# INITIAL FIRE SAFETY INSPECTION REPORT

## Toptex Sweaters Ltd (Annex Building)

Date: 10 April-2025

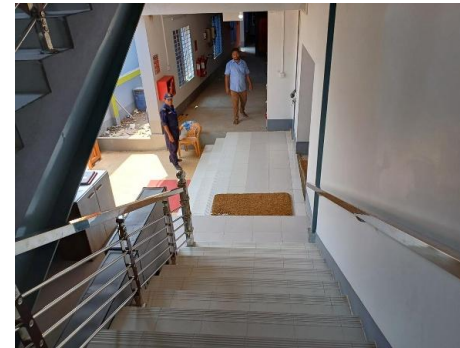
Table-1:				
SI No.	Category	Findings	Required Action	Remediation Time Frame
F-01	Means of Egress	<p>The exit stair enclosures are not separated from work areas and other spaces on each floor by fire-rated construction.</p> <p>Location: <b>All floors.</b></p>	<p>The exit stair enclosure shall be provided with a minimum 1-hr fire resistance rating for buildings with 3 or fewer stories and a minimum of 2- hr. fire resistance rating for buildings 4 or more stories. Provide 1-hr. fire rated door and seal all penetrations and openings by 1 hr. fire rated fire rated barrier construction for building with 3 or fewer stories. Provide 1.5 hr. fire rated door and seal all penetrations and openings by 2 hr. fire rated fire rated barrier construction for building with 4 or more stories in accordance with section 6.3.1.2 of RSC Technical Guidelines (Standard)<sup>1</sup> V1.0.</p> <p>Provide a fire-resistive rated assembly between the exterior exit stairs and the building up to 10 ft. beyond the end of the stair to achieve the required separation. The rated assembly shall be approved and/or designed by a qualified fire protection engineer.</p> <p>Ensure that the fire doors are self-closing and positive latching and that they are provided with fire exit (panic) hardware where serving production floors. If fire doors are required to be held open for functional reasons, provide automatic closing devices tied to the fire alarm system.</p>	Within 3 Months

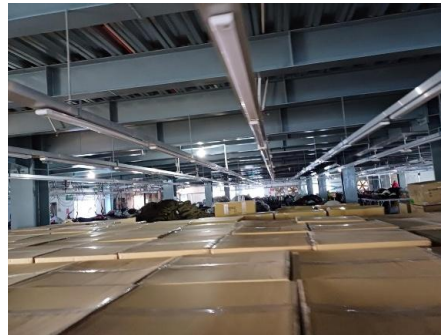
F-06	Fire Rated Construction	<p>Areas used for in-process storage of combustible materials are open to the surrounding occupancy.  Location: <b>1st floor.</b></p>	<p>Provide defined storage areas and limit the storage arrangement as follows:  Maximum height of 2.45 m and maximum area of 23 m<sup>2</sup> and is separated by a minimum 3.0 m (10ft) from other storage areas and they do not exceed 10 percent of the building area of the story in which they occur.  or,  If sprinkler protected, Maximum height 12 ft (3.66 m) and maximum area of 1000 ft<sup>2</sup> (93 m<sup>2</sup>) and separated by a at least 25 ft (7.62 m) and does not constitute more than 10 percent of the building area or 4000 ft<sup>2</sup> (372 m<sup>2</sup>) of the sprinklered area, whichever is greater.  or,  Enclose the storage area from the surrounding occupancy with a minimum 1 hour construction.</p>	Within 3 Months
------	-------------------------	---	--	-----------------

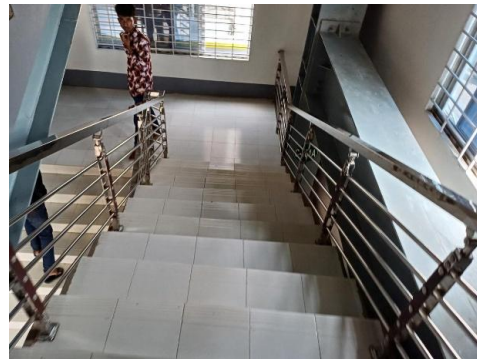
F-09	Means of Egress	<p>Stair width was found less than 60 inch.</p> <p>Location: 54 in for <b>stair-2</b>.</p>	<p>Stairs shall have a minimum width of 60 in for all industrial occupancies as per RSC Technical Guideline (Standard) section of 6.5.6</p>	Within 3 Months
------	-----------------	--	---	-----------------

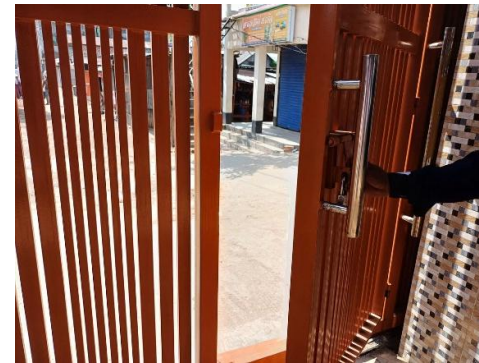
F-12	Means of Egress	Building does not have occupant load signs at required location.	Post the occupant load for every assembly and production floor in a facility in a conspicuous space near the main exit or exit access doorway for the space in accordance with RSC Technical Guidelines (Standard) <sup>1</sup> V1.0 Section 6.4.4.	Within 1 month
F-13	Means of Egress	Egress door serving 50 or more occupants but does not swing in the direction of egress travel. Location: <b>Ground floor.</b>	Modify swing direction of egress doors to the direction of egress travel. Doors serving an occupant load of more than 50 shall swing in the direction (out-ward) of egress travel .in accordance with section 6.8.1 of RSC Technical Guidelines (Standard) <sup>1</sup> V1.0.	Within 1 Month

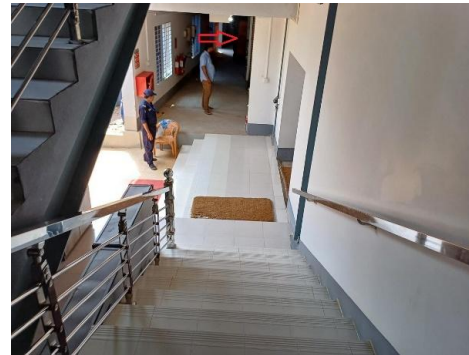
F-17	Means of Egress	<p>Electrical panels were located in the exit stair enclosure without separation from stair-2. Location: <b>Ground floor.</b></p>	<p>Remove and re-locate all electrical panels and water pumps from exit stair enclosures. Or, Provide fire separation with stair enclosure in accordance with section 6.3.1 of RSC Technical Guidelines (Standard)<sup>1</sup> V1.0.</p>	Within 3 Months
------	-----------------	---	--	-----------------

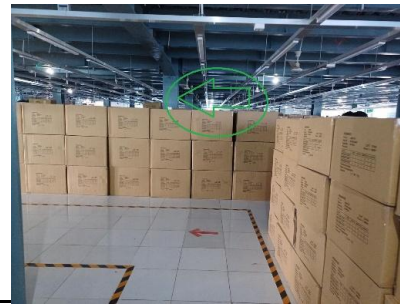
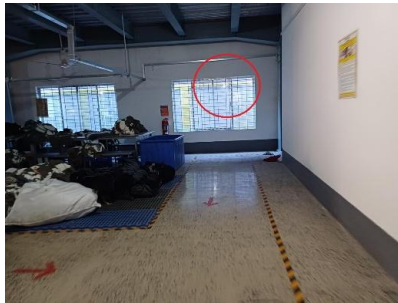
F-21	Means of Egress	<p>Directional signs are not provided where direction of the path of travel to an exit has changed. Location: <b>All floors.</b></p>	<p>Illuminated directional signs shall be provided where there is a change in the direction for the path of travel and the direction to an exit is not obvious in accordance with RSC Technical Guidelines (Standard)<sup>1</sup> V1.0 Section 6.11.3.</p>	Within 1 Month
------	-----------------	--	--	----------------
